Access Compliance Report

Public Rights-of-Way

(Curb Ramps)

Intersection ID: 29416	Main Street: PADDARBORN_CT	Cross Street: SALINGER_WY	Location: NW
ADA ID: A8D4684A1EA8	Ramp Type: Perp	Initial Pass/Fail: Fail	Overall Compliance: No
Severity Score: 12.5			
Codes/Mitigation Info/Possible Solution		Field Measurements/Component Compliance

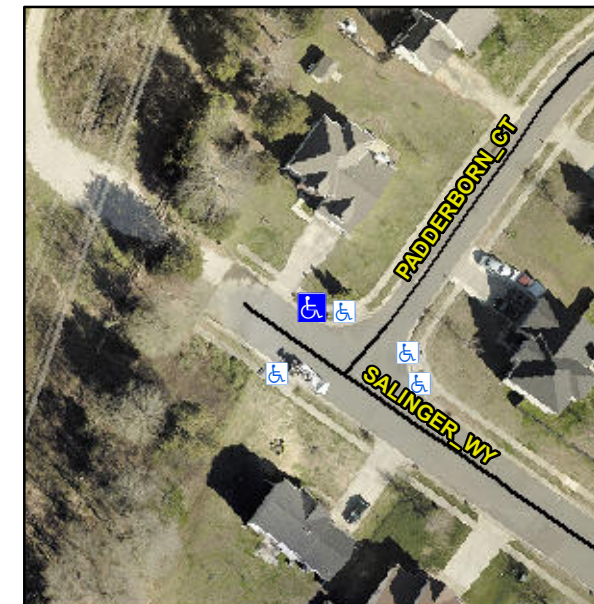
Not Found, R304.2.2

Compliance	Description	Data	Compliance	Description	Data
N/A	Ramp Length (in)	49.0	No	Ramp Slope (%)	11.6
Yes	Ramp Width (in)	48.0	Yes	Ramp XSlope (%)	1.1
N/A	Flare Type LT	N/A	N/A	Flare Type RT	N/A
N/A	Flare Slope LT (%)	N/A	N/A	Flare Slope RT (%)	N/A
N/A	Flare Traversable LT?	N/A	N/A	Flare Traversable RT?	N/A
N/A	Landing Length (in)	N/A	N/A	DWS Provided?	N/A
N/A	Landing Width (in)	N/A	N/A	DWS Contrast?	N/A
N/A	Landing Slope (%)	N/A	N/A	DWS Length (in)	N/A
N/A	Landing X Slope (%)	N/A	N/A	DWS Full Width?	N/A
N/A	Landing Curb? (Y/N)	N/A	N/A	DWS Offset (in)	N/A
N/A	Shared Landing?	N/A			
N/A	Gutter Ponding?	N/A	N/A	Gutter Slope (%)	N/A
N/A	Gutter Lip Ht (in)	N/A	N/A	Gutter X Slope (%)	N/A
N/A	Painted X Walk1?	No	N/A	Painted X Walk2?	N/A
	X Walk 1 Direction	To SW		X Walk 2 Direction	N/A
N/A	X Walk 1 Width (in)	N/A	N/A	X Walk 2 Width (in)	N/A
	X Walk 1 Slope (%)	3.8		X Walk 2 Slope (%)	N/A
	X Walk 1 X Slope (%)	2.1		X Walk 2 X Slope (%)	N/A

Remove & Replace Entire Ramp.
